000 91 13.2 – ADDENDUM NO. 2

- A. Project Name: Pacific Building Conversion
- B. Owner: Kitsap County Department of Human Services
- C. Architect: Rice Fergus Miller, Inc.
- D. Architect Project Number: 2021056.01
- E. Date of Addendum: November 29, 2023

4 DUMPSTER ENCLOSURE - FRONT ELEVATION
1/4" = 1'-0"

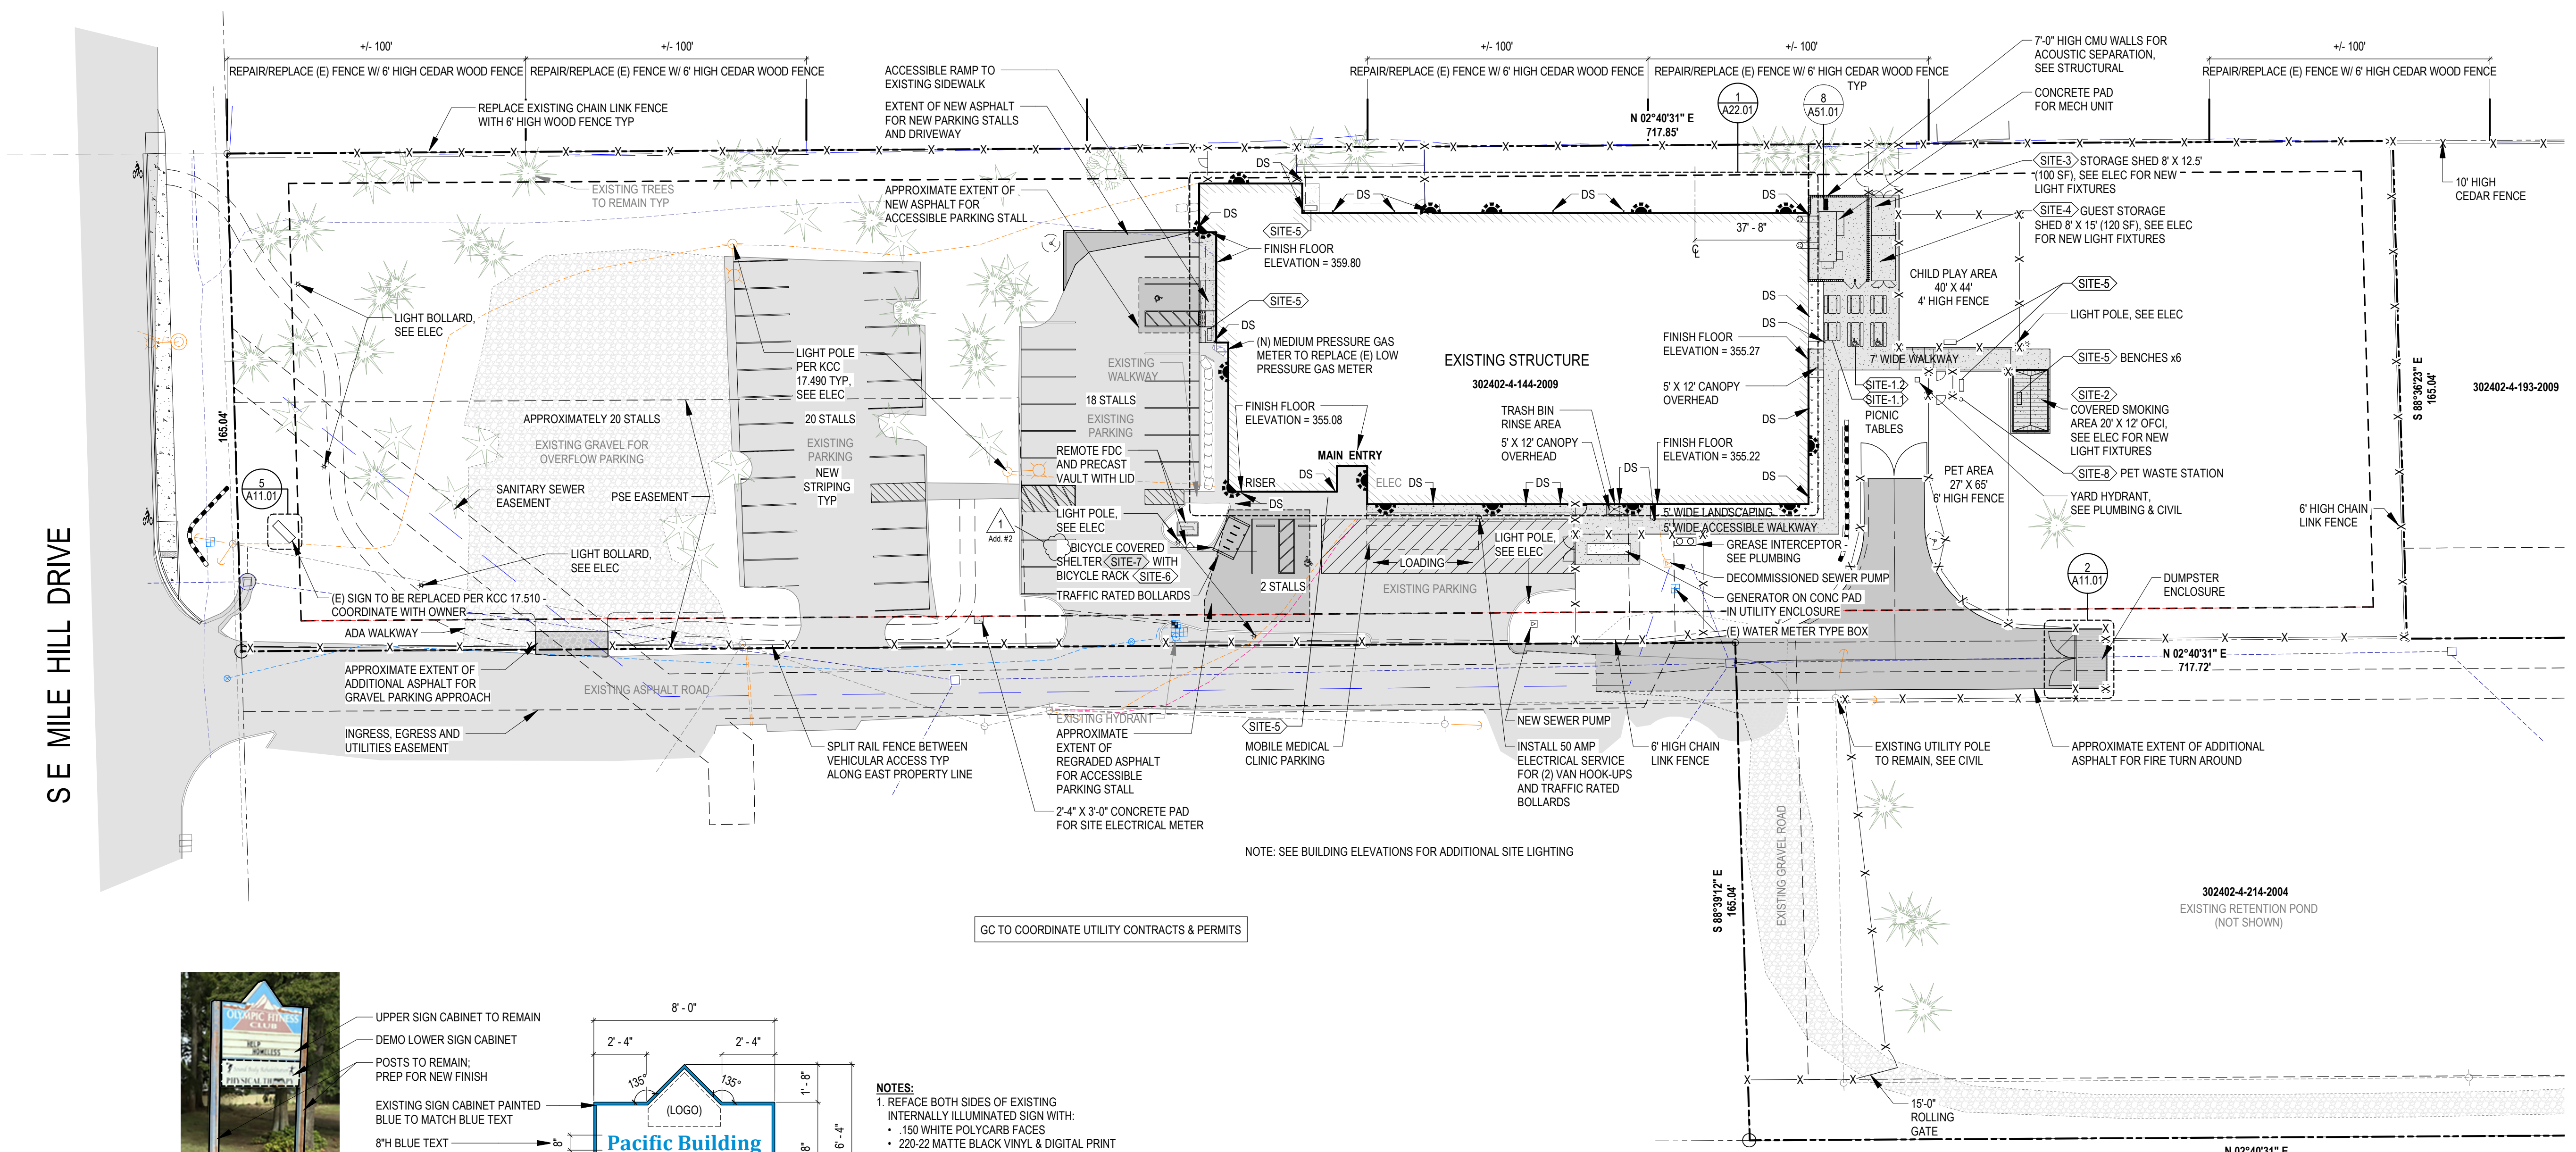
- ITEM 4. Sheet A11.01 – REPLACE in its entirety:
- a. Removed “4” from SITE-7 bicycle covered shelter note. The bike rack is existing.
- ITEM 5. Sheet A21.01 – REPLACE in its entirety:

- Q18. Section 32 33 00 SITE FURNISHINGS – Site furnishings are indicated on Sheets L1.01; A11.01; A81.01 and S4.25. Site 7 Bicycle Covered Shelter is CFCI, however the note on detail 8 on S4.25 states Bike Shelters by others. It also states that the Contractor is to verify structural stability. Please confirm that the GC should add Engineering Costs to purchase a specified structure. In the specification SITE 7 has the capacity of 8 bikes, yet A11.01 calls out a bicycle capacity of 4. Please clarify.

- A1. Yes – Bidders should include Engineering Costs for Site-7 bicycle covered shelter.
- A2. Removed "4" from bike rack note on Sheet C3.00 and from Site-7 bicycle covered shelter note on Sheet A11.01. The bike rack is existing equipment with an 8-bike capacity.

1 ROOF PLAN
1/8" = 1'-0"
0 5 10

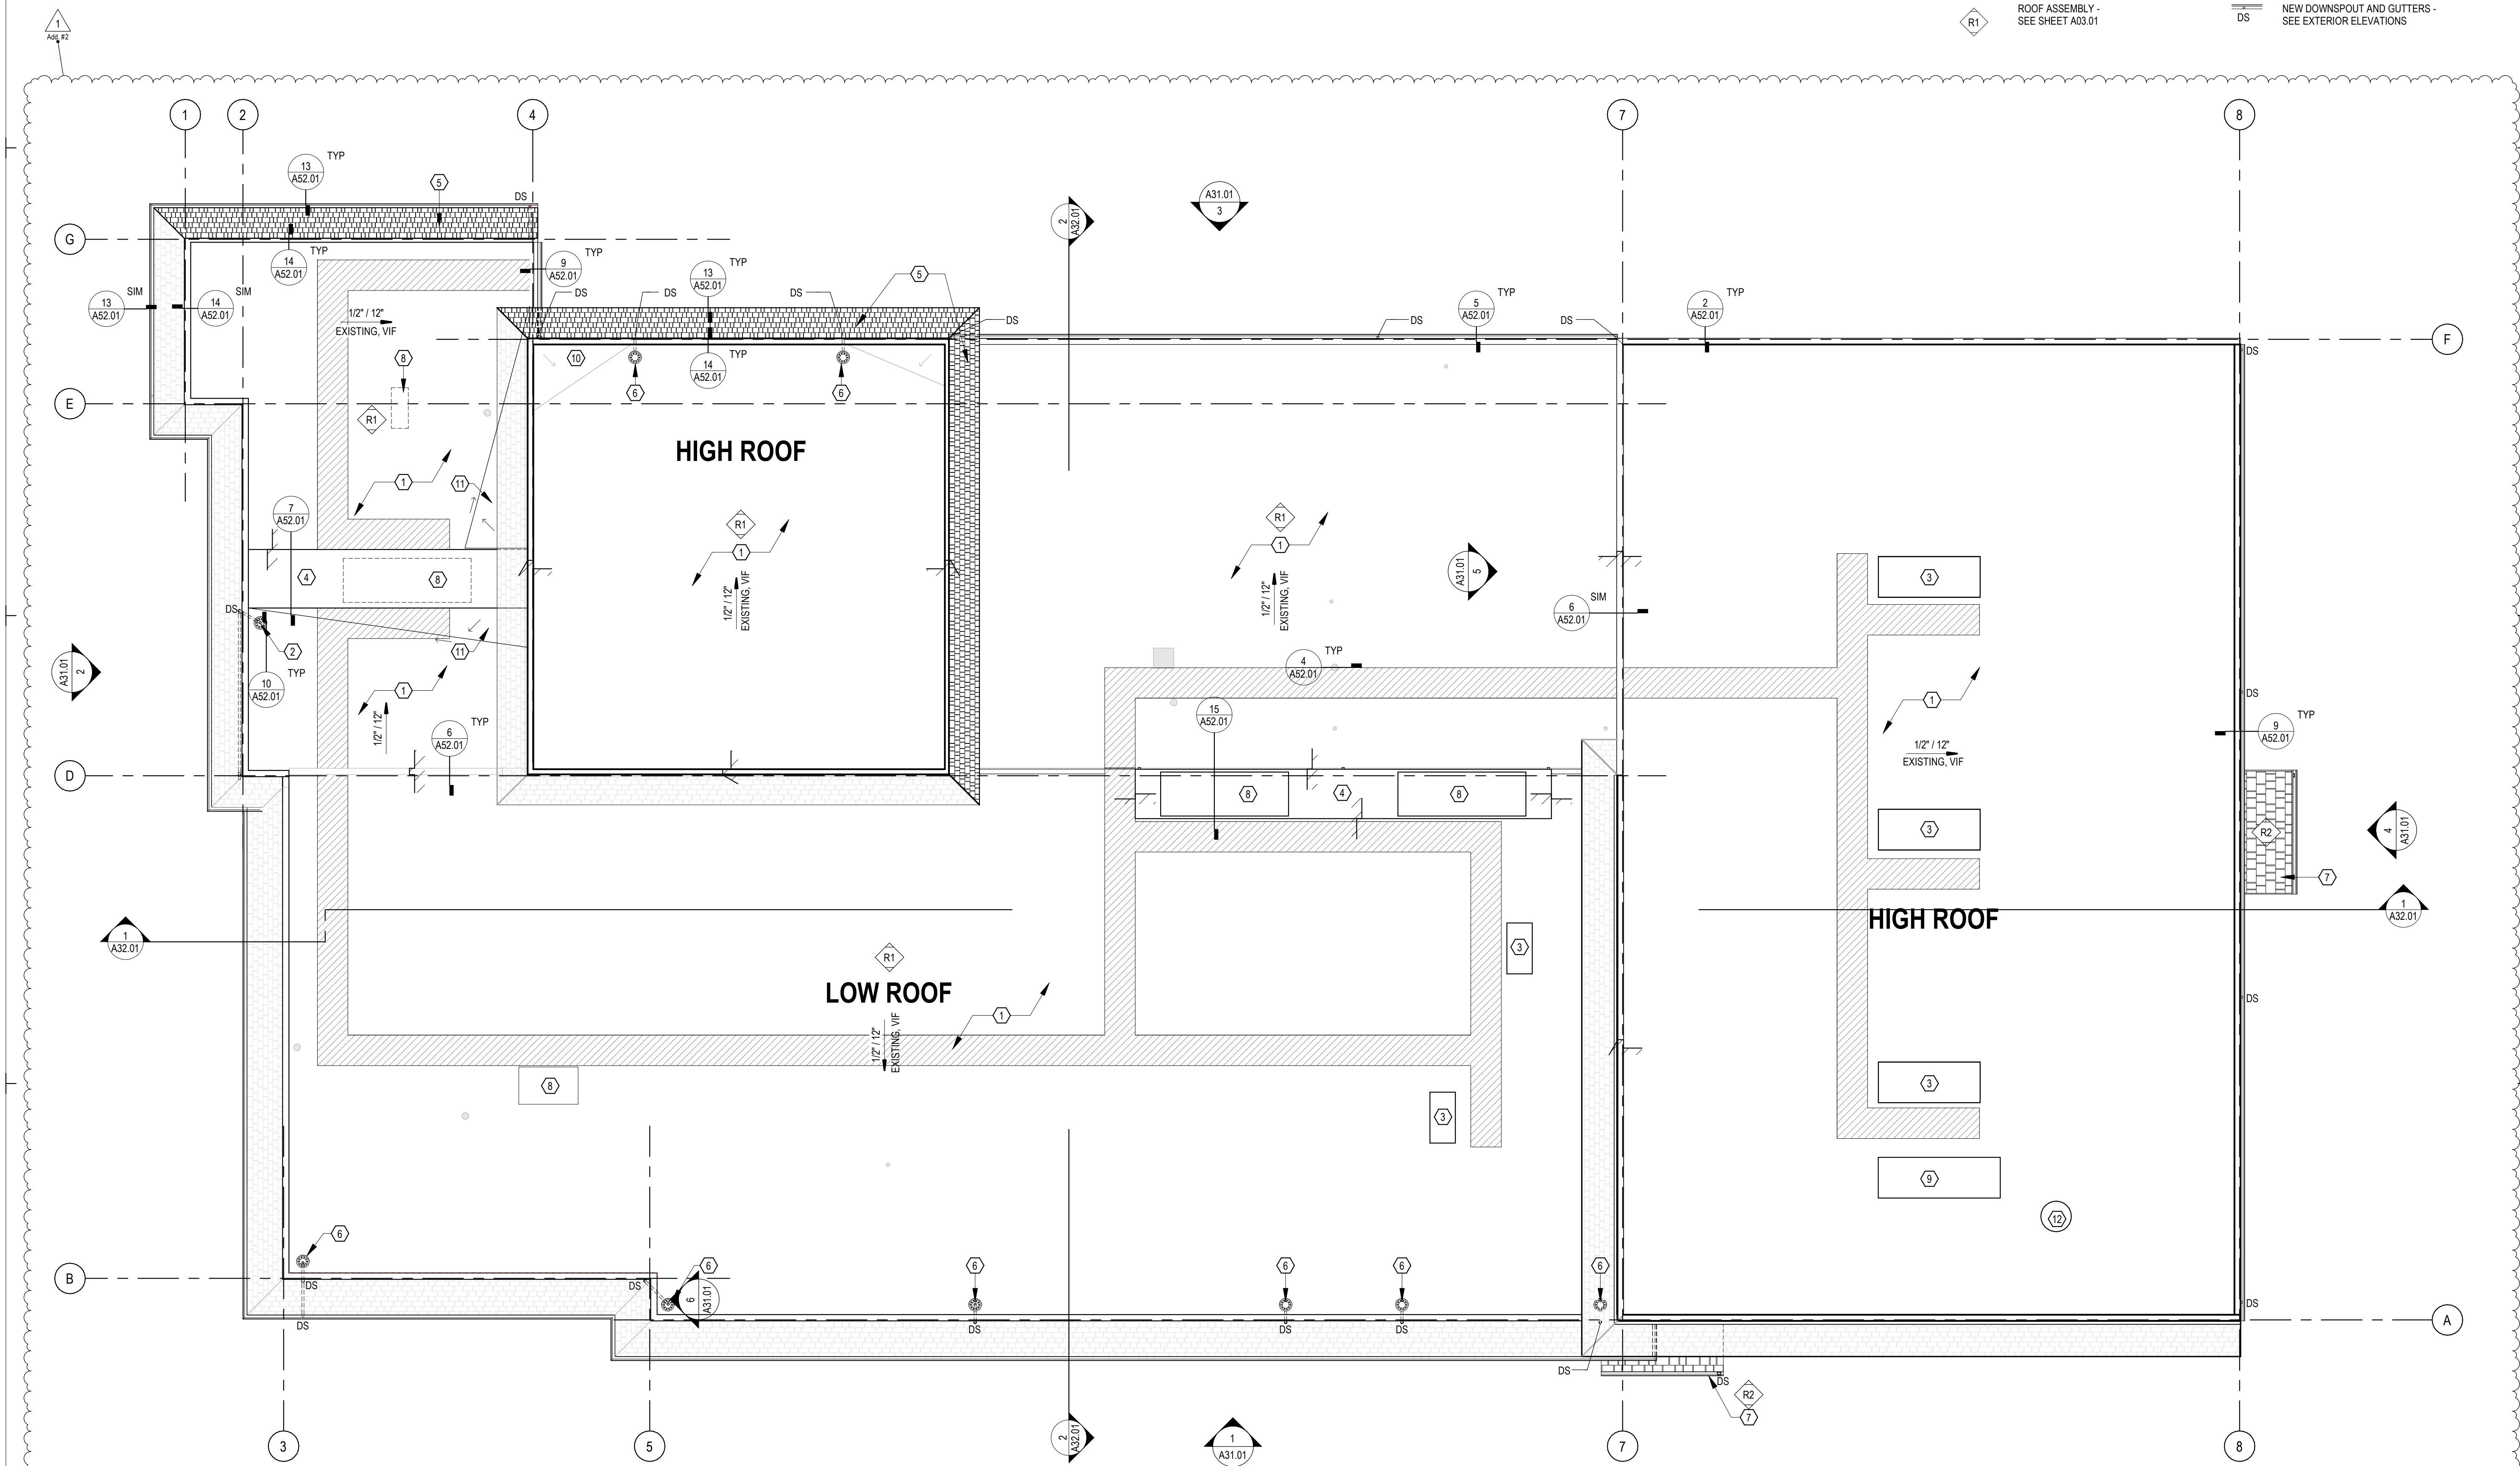
- a. Added floor sinks in Kitchen.
- ITEM 6. Sheet A25.01 – REPLACE in its entirety:
- a. Revised roof walkway pad layout.
- ITEM 7. Sheet A26.02 – REPLACE in its entirety:

6 KITCHEN MEZZANINE
3/4" = 1'-0"

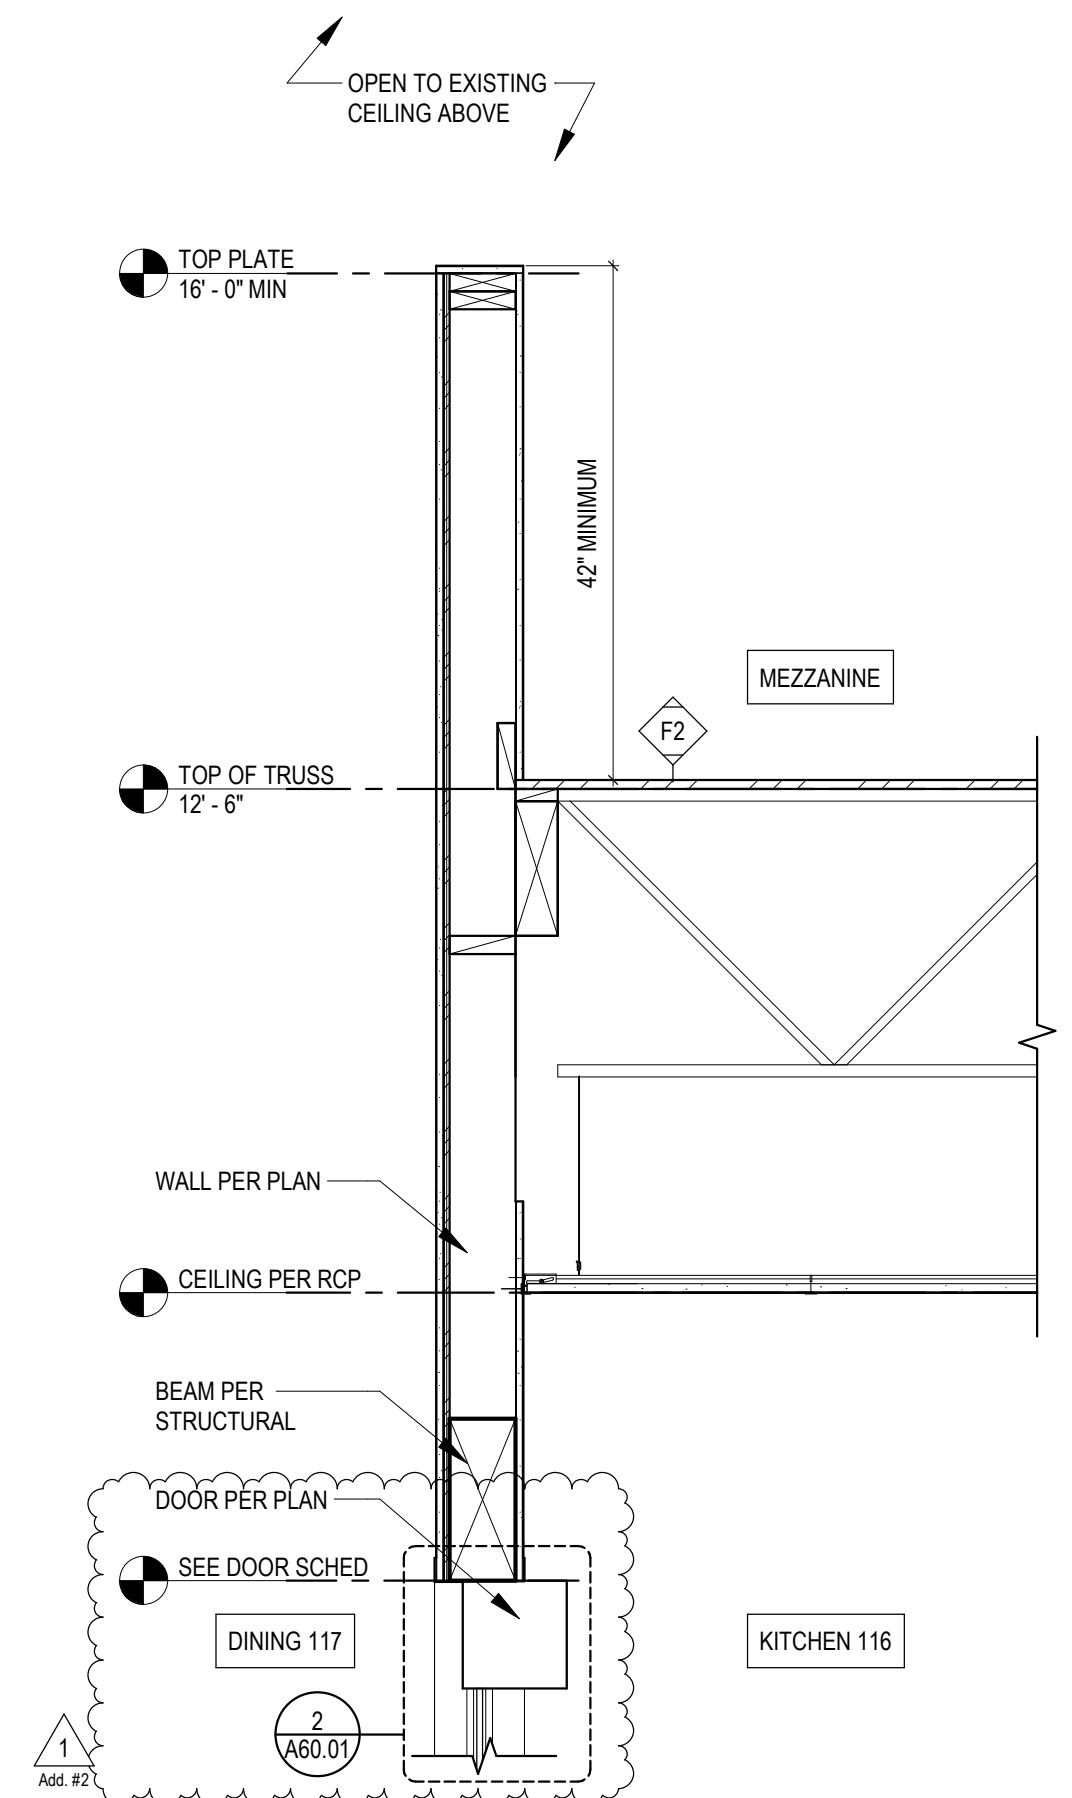
- ITEM 10. Sheet A72.01 – REPLACE in its entirety:
- a. Revised Detail 6 to show between jamb mounted coiling counter door and added header detail callout.
